Major Project Presentation 2

by Michael Lewis

GRADEMARK REPORT

Sample-and-hold circuit implementation

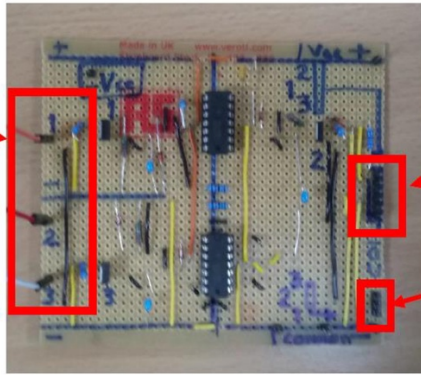
Some evidence provided of testing of search coil with useful waveforms showing the input and output

of the sample and hold circuit. Much of the testing was not possible due to problems encountered during the implementation phase. The components that were completed could have been tested more vigorously through simulation or the construction of a test bed. Project outcomes were clearly evaluated and a percentage completion stated with reasons which were mainly put down to factors outside the control of the student. The actual costs were stated as an approximate value and compared to the budget. However, there was too much emphasis on what went wrong. Could have focused more on what was achieved rather than why things weren't. Conclusions were offered and recommendation given for progressing the project. However, the initial recommendations were mainly a personal reflection on what had gone wrong. (13/30)

-  Good solutions provided for sample and hold circuit with a good explanation of stepper motor driver circuit. A flow chart of the program would have helped to understand the operation of the software code. No evidence provided for design of the PC communications but some reference was made to the user screen and that these were explained in the report as part of the C code. The design solution appears to be the best of the 3 options and is suitable for the problem in theory, but given the lack of progress this could not be confirmed. Clear evidence of use of equipment in the design and construction of the project. No evidence provided of programming tools used. Construction was limited to the veroboard circuits. The images of the prototype showed a reasonable level of quality for development. However, the final product could have been a PCB but this stage had not yet been reached. No parts of the mechanical system had been constructed other than the stepper motor itself. (12/25)
